# MPM Silicones Response Submittal CD

Approximate Chronological Compilation of submitted docs Self-implemented assessment 2007 thru WWTP upgrade excavation 2008 & invoicing 2009

Re: PCB Characterization - Phase III SB-71

Momentive Performance Materials Inc. Plant, Friendly, West Virginia

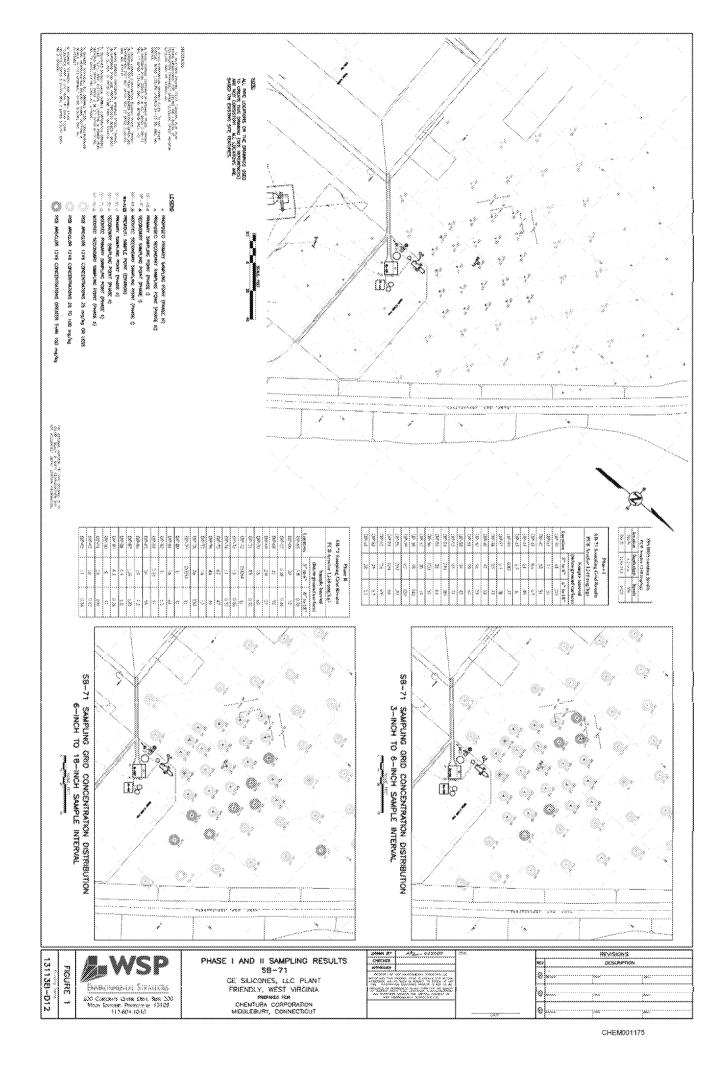
Hi Tom - As per our discussion today, the proposed Phase III sampling plan, which is attached to your e-mail below, is acceptable.

I am concerned about possible PCB contamination of sediments in Sugar Camp Run

located in the northwest area near sample locations DP-71 and Sampling of the Sugar Camp Run may be necessary depending on the results of Phase III. We can discuss this further once you get the results back from this next phase of sampling.

The proposed grid pattern for the SB-71 area is shown on Figure 1, with sampling locations at 25-foot grid intersections and 15-foot grid intersections. Based on the previous sampling results, a 25-foot grid-intersection length is recommended to delineate the potentially affected soil to the west of the Phase II sampling grid. In the northwest area of the Phase II sampling grid, directly north of the sample locations DP-71 and DP-78, a 15-foot grid-intersection length is

recommended to delineate this area due to the close proximity to Sugar Camp Run. In the area to the east of the Phase I sampling grid, the Phase II sampling grid locations were not collected through the concrete slab at the drum flush pad. The proposed grid pattern for the drum flush pad area will be at 25-foot grid intersections. A total of 37 locations will be sampled from the intersection points located by the Phase III sampling grid. The samples closest to SB-71 will be designated as primary sample locations. Samples collected at the edge or corner of the grid will be designated as secondary sample locations. Using the same approach as in the Phase I and Phase II, samples will be collected from each grid point from 0 to 3 inches beneath surface cover or gravel, if present, using direct-push technology. An additional sample from each location will be collected from 3 to 15 inches below the surface sample. At the sampling locations in the drum flush pad, two additional samples will be collected from each location at 15 to 27 inches below the surface and at 27 to 39 inches below the surface sample (based on Geoprobe tube lengths of 4 feet). These samples collected at depth will be designated as secondary samples. The primary samples will be submitted to the laboratory to be analyzed immediately. The secondary samples will be submitted to the laboratory, the initial extraction will be completed, and the samples will be archived pending the results of the primary samples.

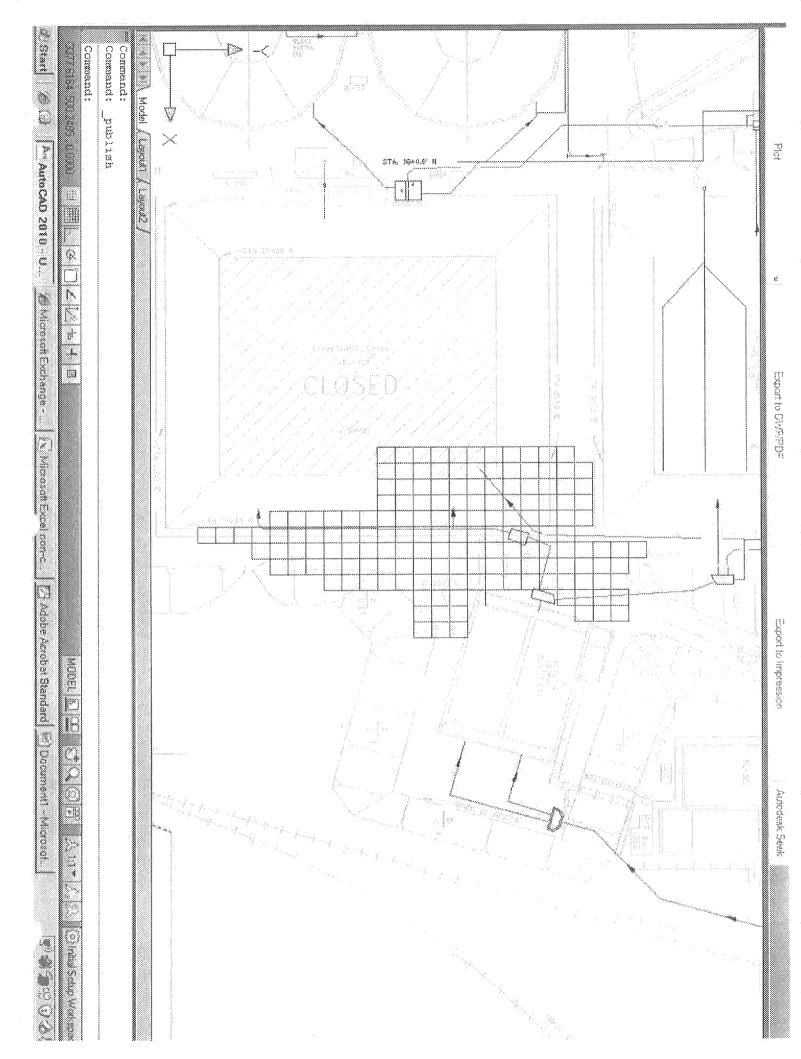
The original grid was 18.29m X 30.48m (60' x 120'), which is 558 square meters. As of 9/9/09, the grid expanded to approximately 1359 square meters. As of this date, a boundary has not been clarified to determine the extent of the contamination. Further sampling and analysis would be required to provide that boundary.

Each cell was 3m X 3m and samples were taken from the top, down to sometimes 30°. The grid was established using EPA guidelines.

Attached is a drawing that depicts the sample grid outlined, and the sample results for each cell within the grid.
